Model: Finisher SR5040/SR5030 (D512/D513)	Date: 20-Jun-11	No.:RD512001a
---	-----------------	---------------

Model: Finisher SR5040/SR5030 (D512/D513)		Date: 16-Dec-11	No.: RD512002
Subject: Finisher SR5030 Exit Roller damage by End Fence.		Prepared by: Hiroaki H Matsui	
From: PP Service Planning Department 1G			
Classification:	<input checked="" type="checkbox"/> Troubleshooting <input type="checkbox"/> Mechanical <input type="checkbox"/> Paper path <input type="checkbox"/> Product Safety	<input type="checkbox"/> Part information <input type="checkbox"/> Electrical <input type="checkbox"/> Transmit/receive <input type="checkbox"/> Other ()	<input type="checkbox"/> Action required <input type="checkbox"/> Service manual revision <input type="checkbox"/> Retrofit information <input type="checkbox"/> Tier 2

Subject: Modification for smooth Shift Tray motion		Prepared by: K. Tsutsui	
From: 1 st PP Tech Service Sec., PP Tech Service Dept.			
Classification:	<input type="checkbox"/> Troubleshooting <input type="checkbox"/> Mechanical <input type="checkbox"/> Paper path <input type="checkbox"/> Product Safety	<input type="checkbox"/> Part information <input type="checkbox"/> Electrica

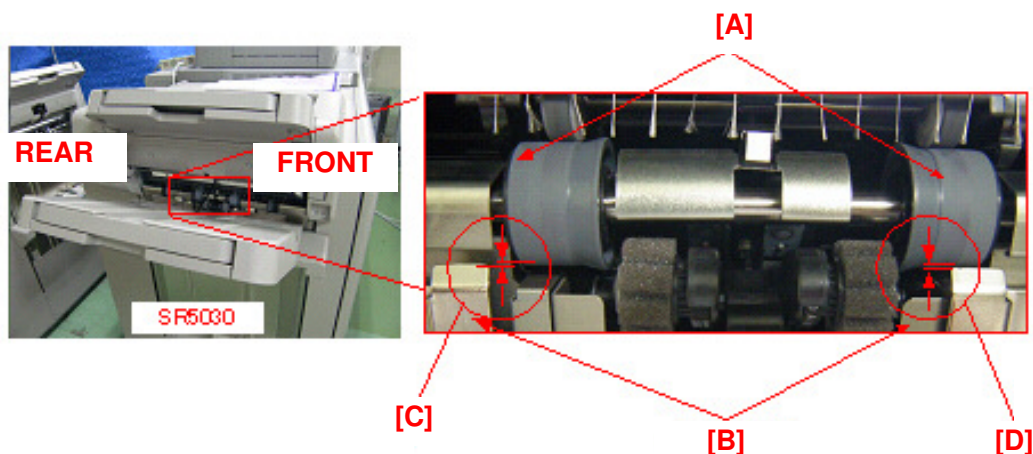
If a sufficient gap [A] is not secured between the End Fence [B] and the Exit Roller [C], the tip of the End Fence [B] could abrade the Exit Roller [C] in the worst case.

A sufficient gap is not secured between the exit roller [C] and the tip of the end fence [B] due to the inaccurate dimensions of the End Fence.

Countermeasure End Fence
(Length of the end fence edges has been shortened to prevent contact with the roller.)

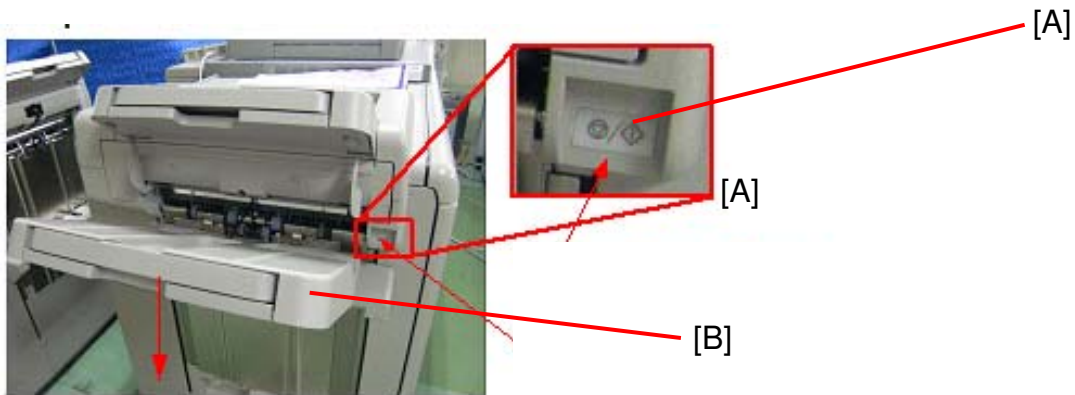
2. If the measurements of the 2 locations [C] and [D] are 2.5 mm (approximately 0.1 inch) or smaller, replace the End Fence and the Exit Rollers with the countermeasure parts as a set.

NOTE: Countermeasure parts are supplied as P/N D0749902 (End Fence Kit).

P/N D0749902 (End Fence Kit) consists of the above two parts.

How to measure the gap

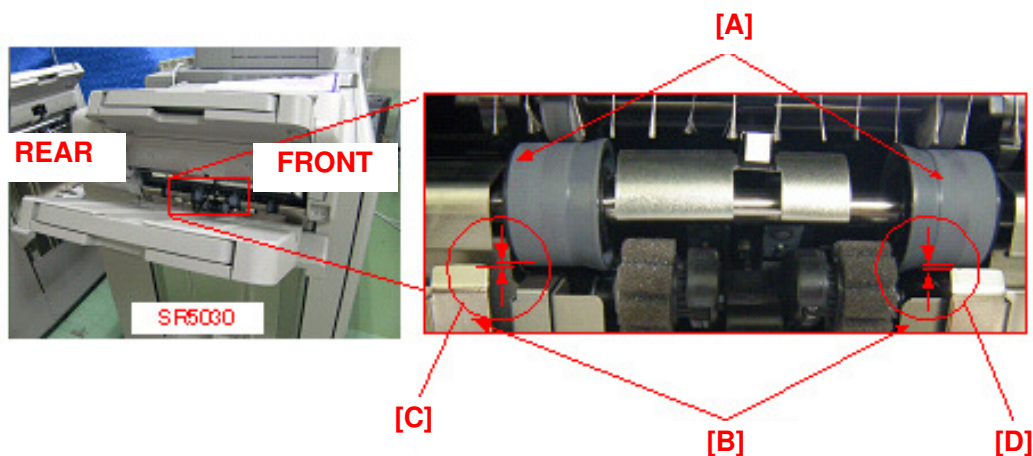
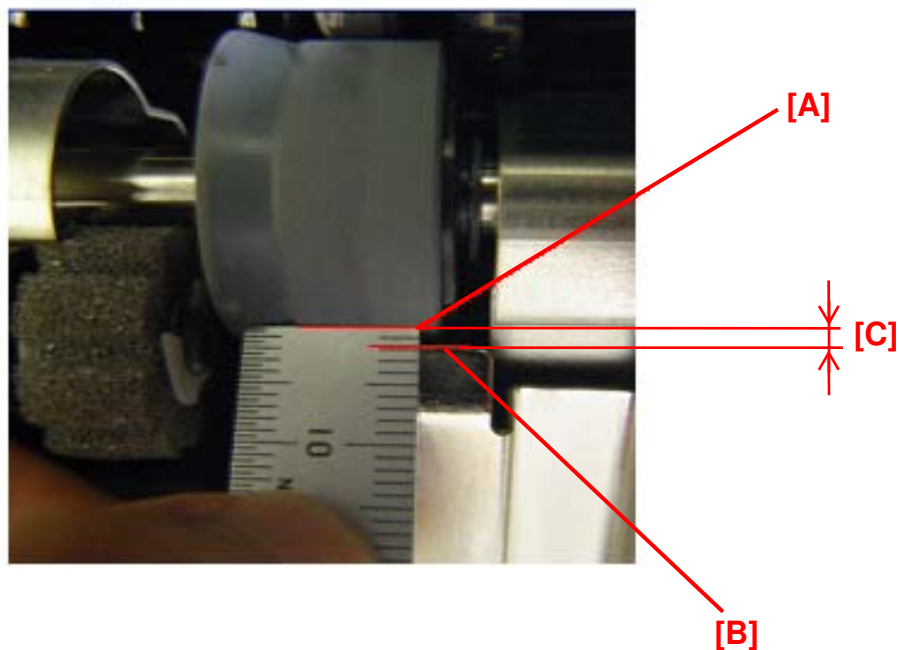
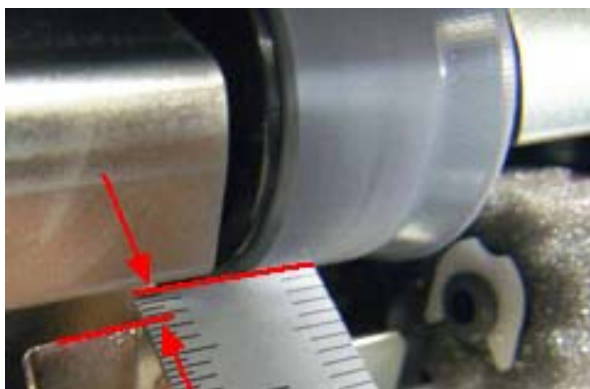
1. On your next service visit, measure the gap between the End Fence and the Exit Rollers ([C] and [D]).

- Place the edge of the ruler [A] flush with the surface of the exit roller and measure the gap [C] between the roller and the tip of the end fence [B].

CAUSE

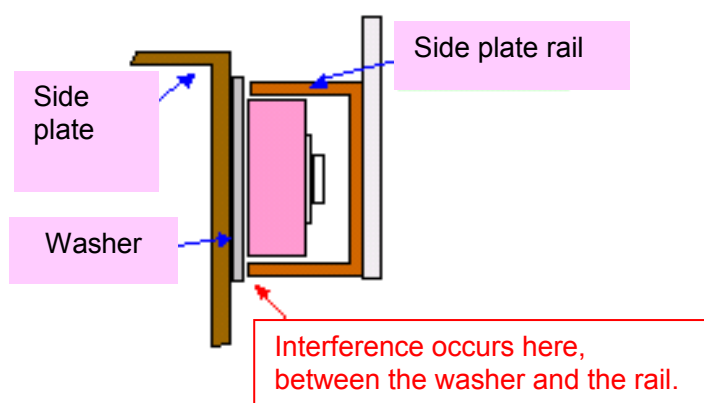
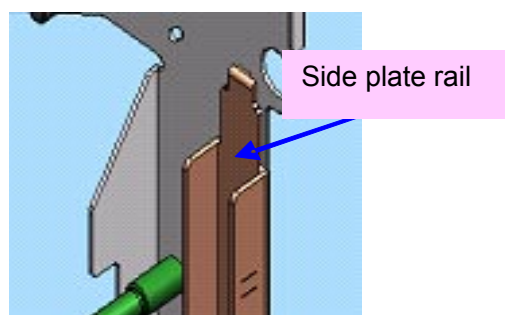
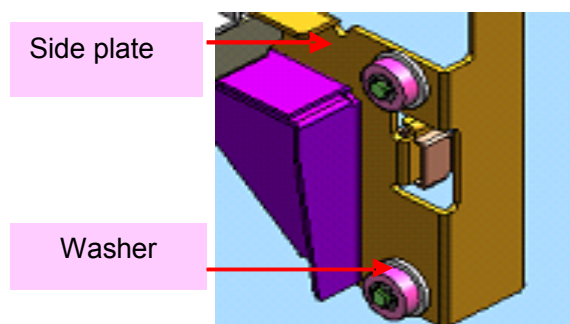
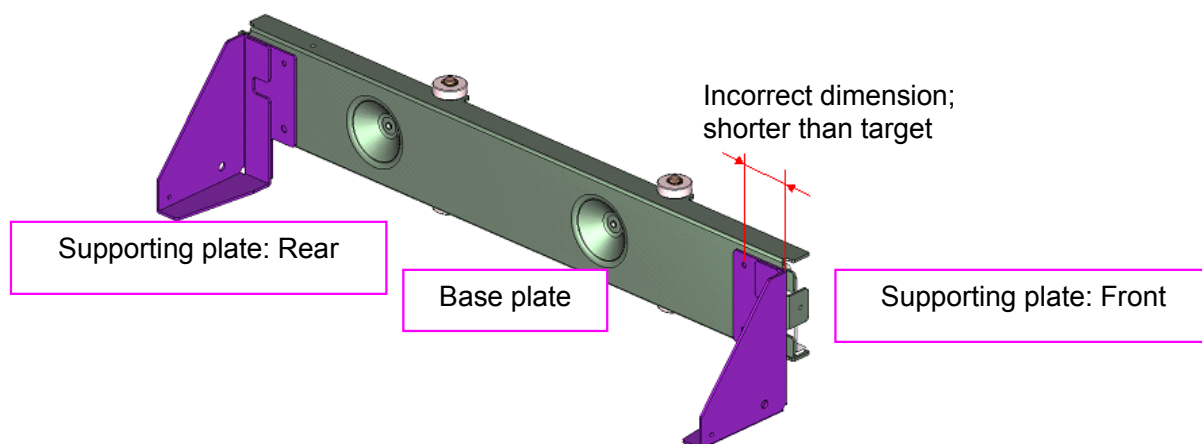
The front and rear supporting plates, which are bent and welded to the base plate, were bent in incorrect dimensions due to a fault in the manufacturing process. This causes the washer installed on the side plate to interfere with the side plate rail, stopping the shift tray from descending.

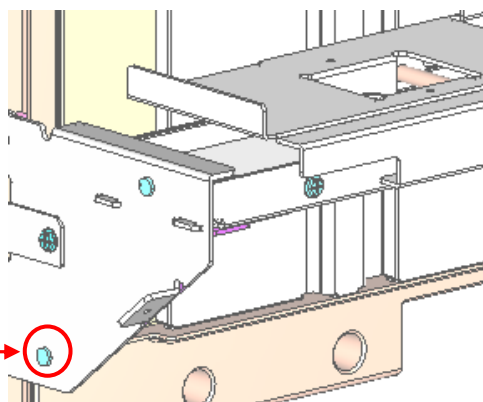
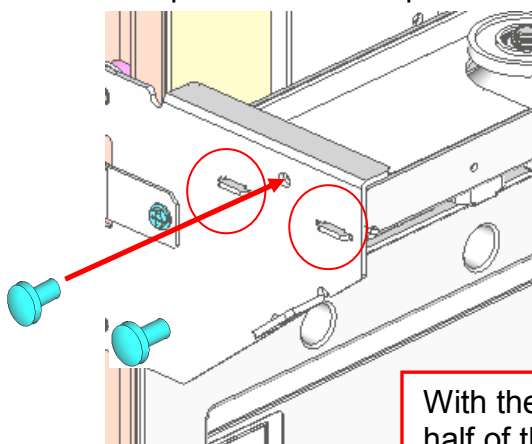
5. Install the washer in between the base plate and the side plate and hook it onto the bottom screw hole that was loosened in step 3. Fasten the bottom screw added with the washer.

Add the washer (0.5mm thick) in between the base plate and the side plate.

The washer is needed only for the bottom screw.
